Certificate of Appropriateness

2145 N. SHERMAN BL.

Sherman Boulevard HD

Summary: Replace roof, rebuild rear porch, rebuild front balcony railing, re-side dormers, replace gutters and downspouts.

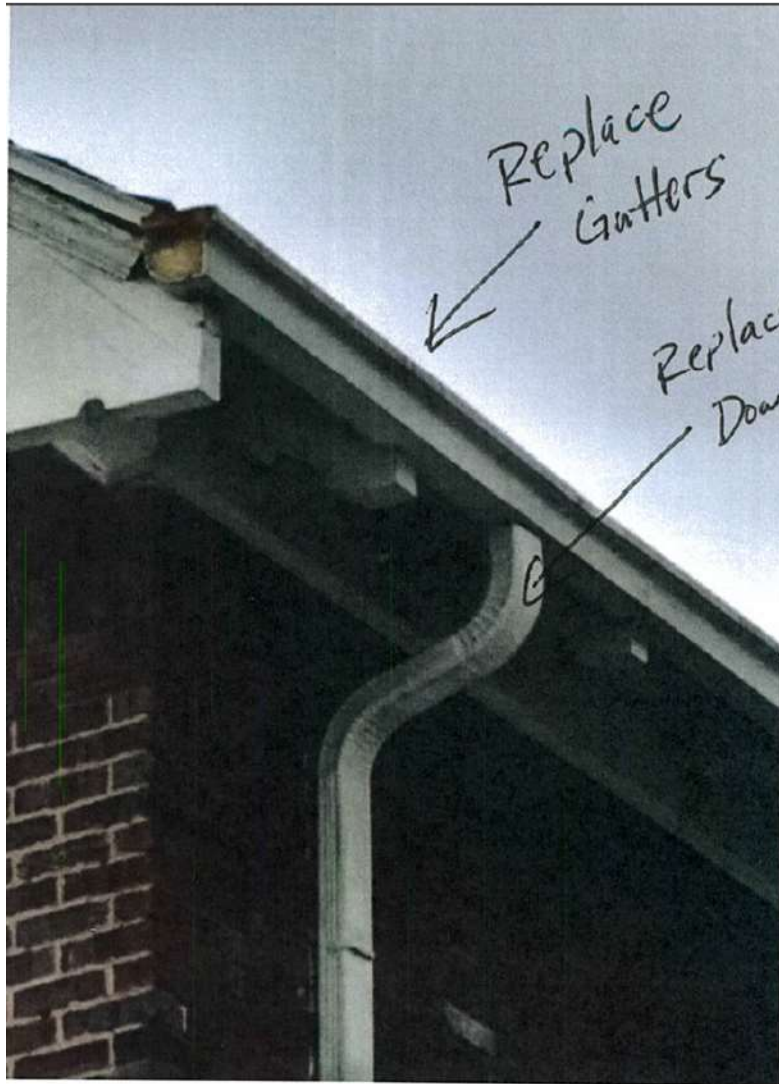
Replace with code-compliant railing in painted red cedar

Replace asphalt siding on dormers with cedar clapboard

Gutters & Downspouts

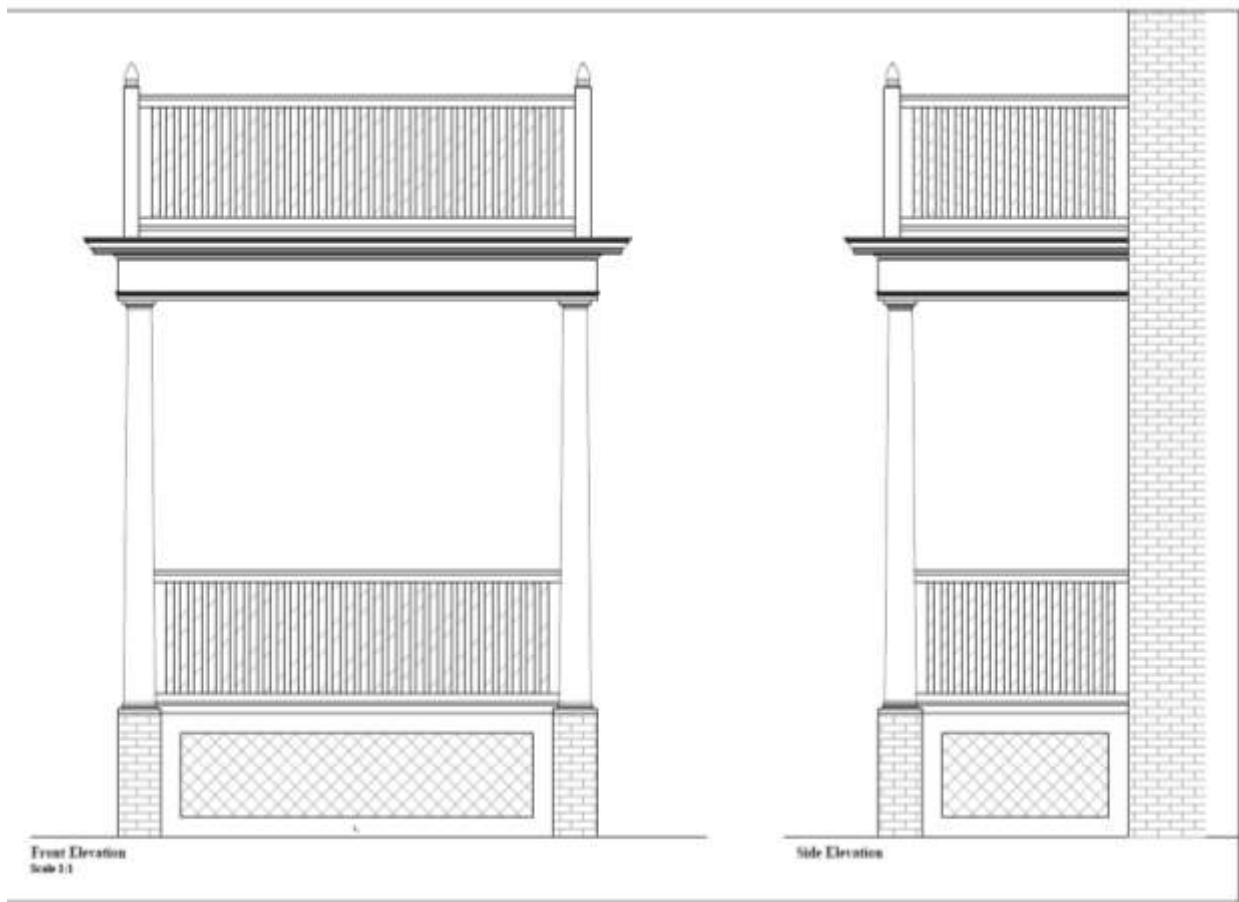
Replace all with new aluminum half-round

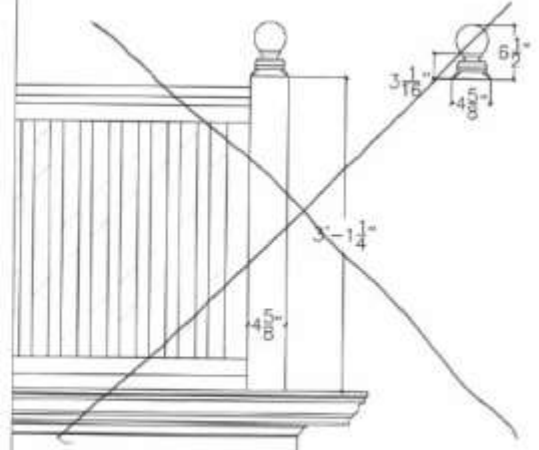
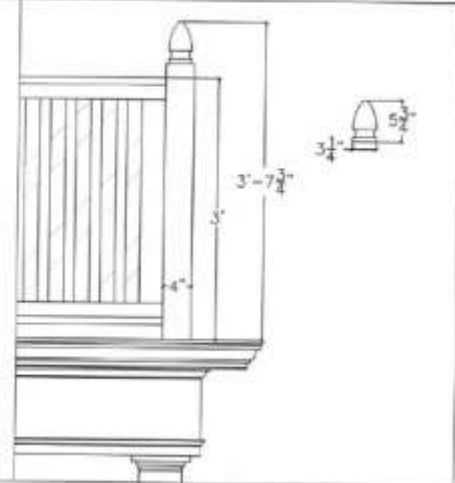
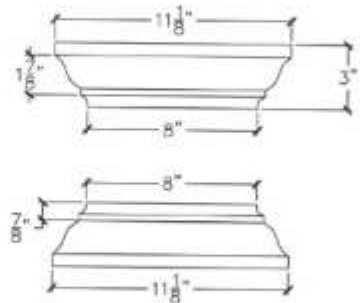
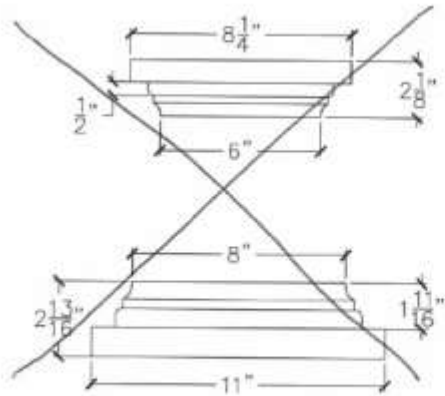
Rebuild to drawings with red cedar finish wood over PT-structure. Will use same railing design for front balcony

Decking and guard rot-resistant wood material, not pressure treated. (One guardrail is specified, as pressure-treated, staff believes this to be a typo in the application.) Decking shall be tongue and groove, installed perpendicular to the nearest house wall.
